Response to Public Comments

City of Cincinnati BSB Corridor Concept I-W and Cincinnati USA Regional Chamber Footprint Minimization

TO: KYTC and ODOT
FROM: HNTB Corporation
DATE: November 2, 2022
RE: Brent Spence Bridge Corridor Project | ODOT PID 89068 | KYTC Project Item No. 6-17

EXHIBIT A:

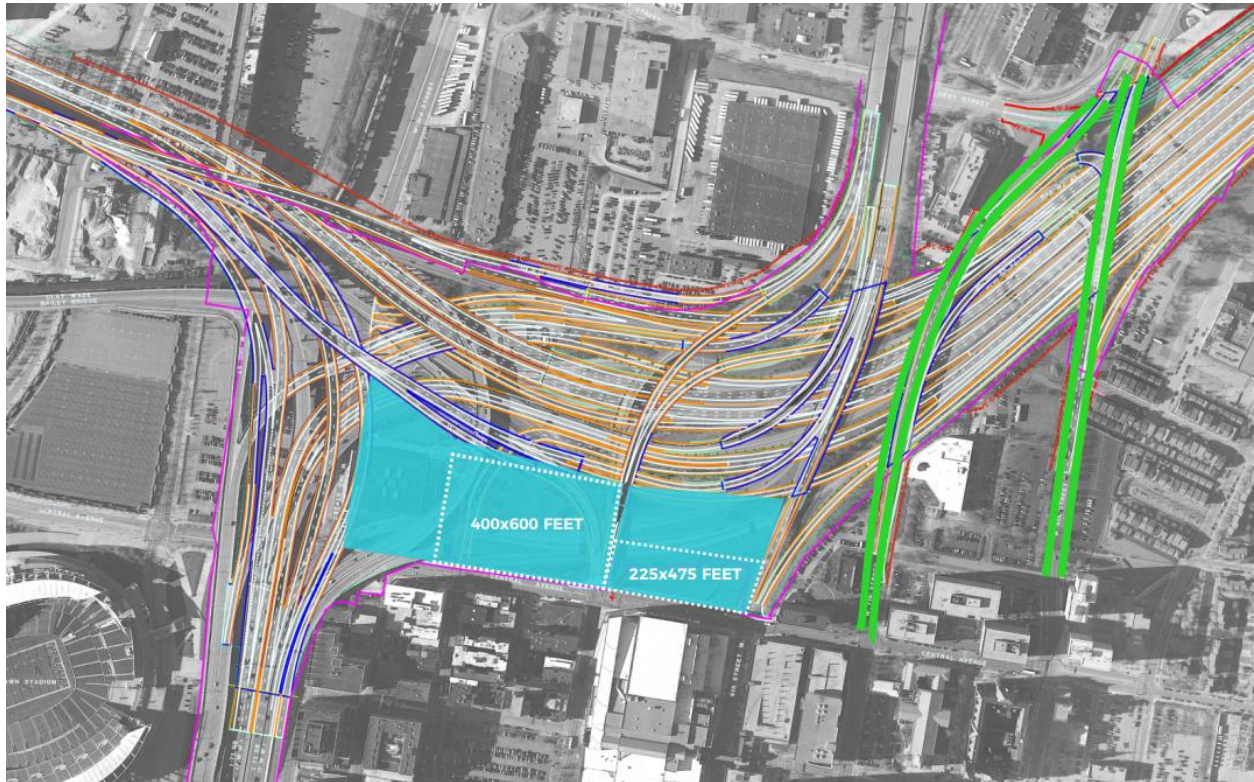
The City would like to evaluate options that would maximize the developable land between Central Avenue and the Interstate network. (Exhibit A) We would ask that ODOT evaluate the following options to help achieve that goal:

- Remove the ramps that access from 4th Street.
 - An additional ramp from 3rd Street to NB I-75.
- Minimize the footprint of the 5th Street ramps.
 - The NB ramp to 5th Street can create a T-intersection with the other ramps coming into 5th Street.
 - Shift the C-D road to the west since the 4th Street ramp is gone.
 - Potentially move to a two-way 6th Street.
- Direct connection from 6th Street to the mainline I75 northbound.
 - With the removal of the 4th Street ramp to the mainline a direct connection from 6th St should be created.
- Support future development
 - The City anticipates John Street being used to support future development in the space created in this area.
 - As design moves forward, ODOT and the City should make sure the interstate design doesn't preclude John St being used to support potential back of house uses for development.

After receipt of the City's comments, ODOT and HNTB met with City staff to discuss potential refinements to Concept I-W in the area between 3rd Street and 7th Street. Following the coordination meeting, HNTB evaluated the following ramp refinements in downtown Cincinnati (see Attachment 2):

- Removing the entrance from 4th Street to northbound I-75.
- Adding an entrance from 3rd Street to northbound I-75.
- Removing the southbound I-75 exit to 5th Street and reducing the number of lanes on the southbound collector-distributor (C-D) road from three to two.
- Reconfiguring the northbound I-75 exit to 5th Street to create a new signalized intersection with the US 50 ramp approximately 300 feet west of Central Avenue.
- Reducing the number of lanes on the eastbound approach to the 5th Street/Central Avenue intersection from four to three.
- Removing the connection between 6th Street and Winchell Avenue.
- Providing a connection between 6th Street and the northbound C-D road and northbound I-75.
- Widening the southbound I-75 ramp to 7th Street from one to two lanes.

BRENT SPENCE BRIDGE CORRIDOR DESIGN BUILD PROJECT - CONCEPT I-W
(ODOT PID 116643 & KYTC KENTON COUNTY 6-17)

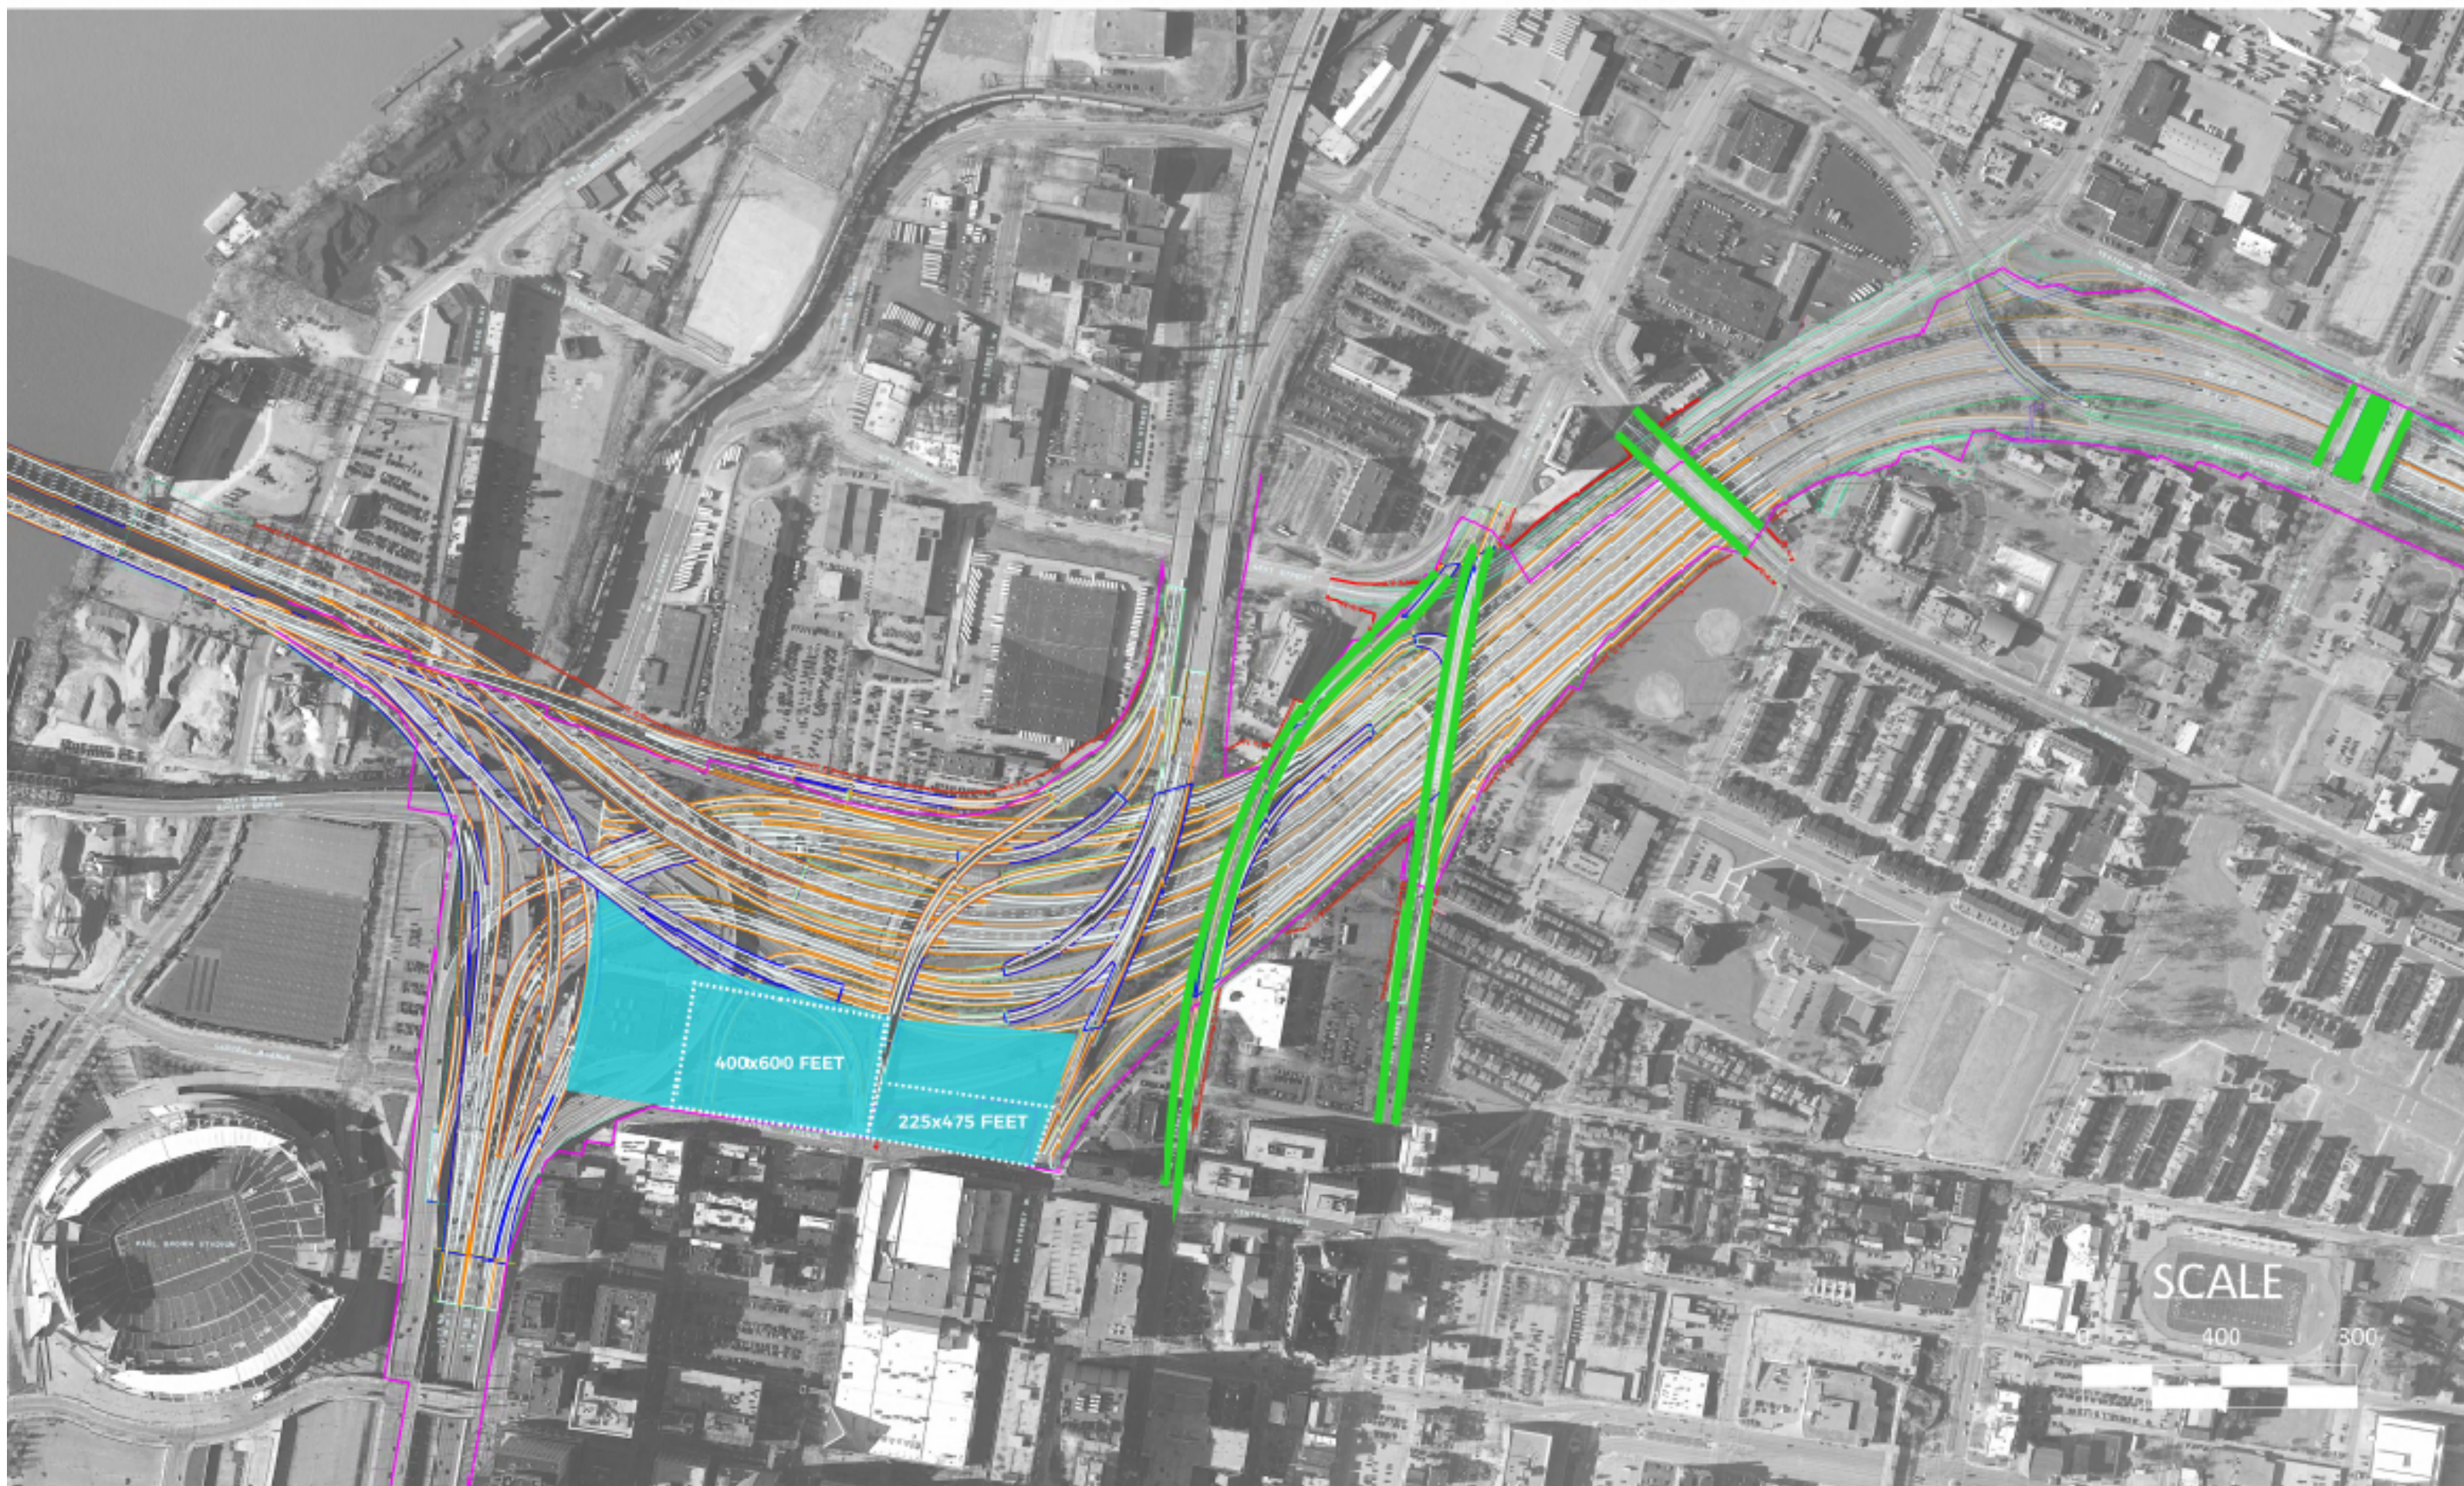
Attached please find the map that was developed over the last month+ with stakeholders we convened to identify and quantify the valuable minimum thresholds for developable land should it be possible to retain it in the design build phase of BSB. A few things worth noting:

1. The Blue sections are the desired areas, while the dotted lines delineate the minimum thresholds for Convention Center opportunities to the west.
2. The green lines indicate the areas where I understand the City and ODOT are discussing Long Street style treatment on connection points across the footprint. Throughout the room there was excitement for this concept and support for it. We included it here to make sure you understood that we were aligned in talking about both.

Figure 1: Concept I-W Design Refinements

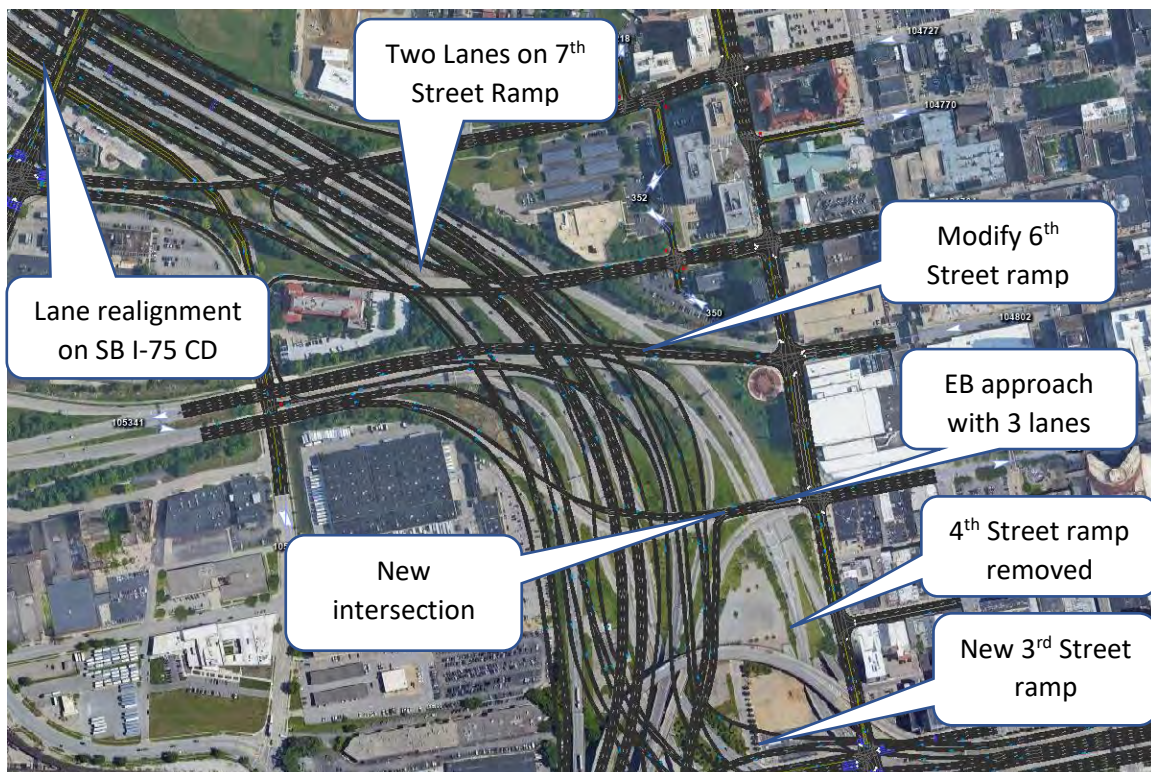
- Removal of SB I-75 Exit to 5th Street
- Removal of the NB I-75 entrance from 4th Street
- Addition of NB I-75 entrance ramp from 3rd Street
- Modification of 6th Street ramp geometry
- New signalized intersection between the NB I-75 exit ramp and US 50
- Reduced lanes for EB approach at 5th Street & Central Avenue Intersection

Due to traffic impacts from the 5th Street ramp removal, additional improvements are recommended for SB I-75 CD and SB I-75 exit ramp to 7th Street. With these proposed changes the traffic operations are acceptable in the project study area captured in the TransModeler network. The IMS forecasts and operations analysis will include additional intersections east of Central Avenue, which will provide a final analysis to understand the traffic impacts of the 4th Street ramp removal. The proposed geometric refinements for Concept I-W are shown in the figure below.

Location	Concept I-W	Proposed Changes
SB I-75 Exit to 5 th Removal		
7 th St Exit Ramp		
I-75 S and 7 th St Ramp diverge

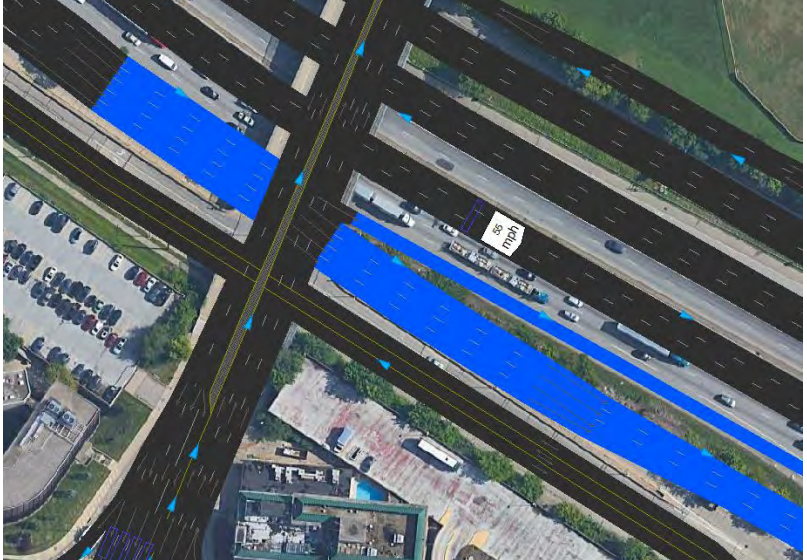
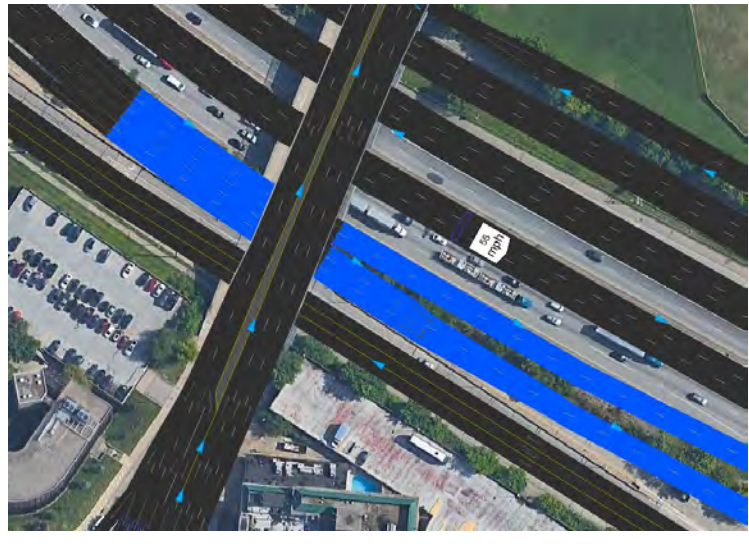
The SB I-75 exit onto 5th St was removed from the Concept I-W design. US 50 and the NB Exit to 5th Street was modified to form a signalized intersection west of Central Avenue. This signalized intersection operates at LOS B or better for both peak hours. The eastbound approach of the 5th Street and Central Avenue intersection is reduced from 4 lanes to 3 lanes. This intersection maintains acceptable operations of LOS B or better.

To accommodate the displaced exiting traffic to 5th Street, a second lane was added to the 7th Street exit ramp. This design change is different from the single lane in Concept I-W but consistent with the existing conditions. The LOS for the SB I-75 CD road before the 7th Street exit ramp changed from LOS B to LOS C during the AM period and remained at an LOS A for the PM period. The volume entering the ramp increased from 3410 vehicles to 6384 vehicles over the course of the 5-hour AM period and 1763 vehicles to 3431 vehicles for the 6-hour PM period. The LOS at the 7th Street and Central Avenue intersection remained at a LOS B for the AM and PM period for this design change.

On the SB I-75 CD road upstream of the 7th Street exit, the road diverges to either 7th Street or continues to 2nd Street, 3rd Street, and Brent Spence Bridge. It was also this section of road where the I-75 exit ramp to 5th Street was located. With the removal of the ramp, a lane was removed from the CD road. The traffic continuing south after the diverge now has three lanes that tapers to two, this tapering distance was shortened to match the distance used in the Concept I design. The LOS for this section changed from LOS B to LOS C during the AM period and remained at a LOS B for the PM period.

Location	Concept I-W	Proposed Changes
4 th St Entrance Ramp		
3 rd St Entrance Ramp

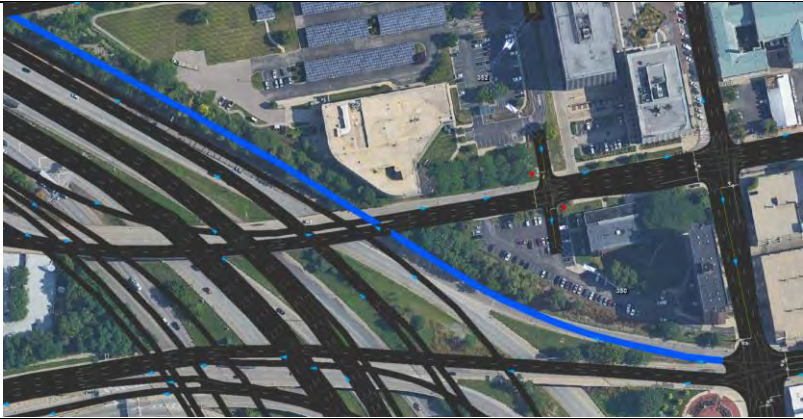
The NB I-75 entrance ramp from 4th Street to the NB CD was removed. The entrance ramp from 3rd Street was modified to include an additional ramp leading to I-75 N to accommodate the displaced northbound traffic. This alteration increased the 3rd Street ramp volume from 829 vehicles to 2553 vehicles over the course of the AM period and 5424 vehicles to 9565 vehicles for the PM period.
